RE: RAAus Organisational Response to 'Lowering Class E on the East Coast' consultation

Lowering Class E on the East Coast – RAAus organisational consultation response

Figure 1

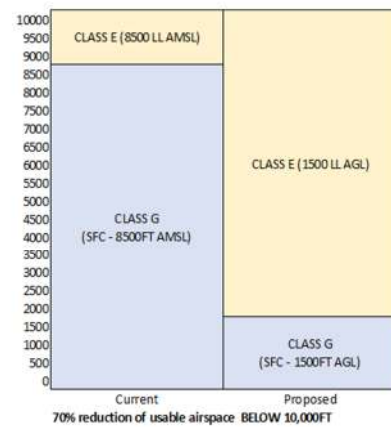
We would also call out the misleading airspace diagram that is contained within the proposal documentation – see Figure 1, and whilst noting it’s meant to be indicative; it does imply that the reduction of Class G airspace is minimal. However, when displayed as a scaled drawing per Figure 2, the vertical reduction of Class G airspace can clearly be displayed as excessive and not at all proportional to that of the Airservices diagram.
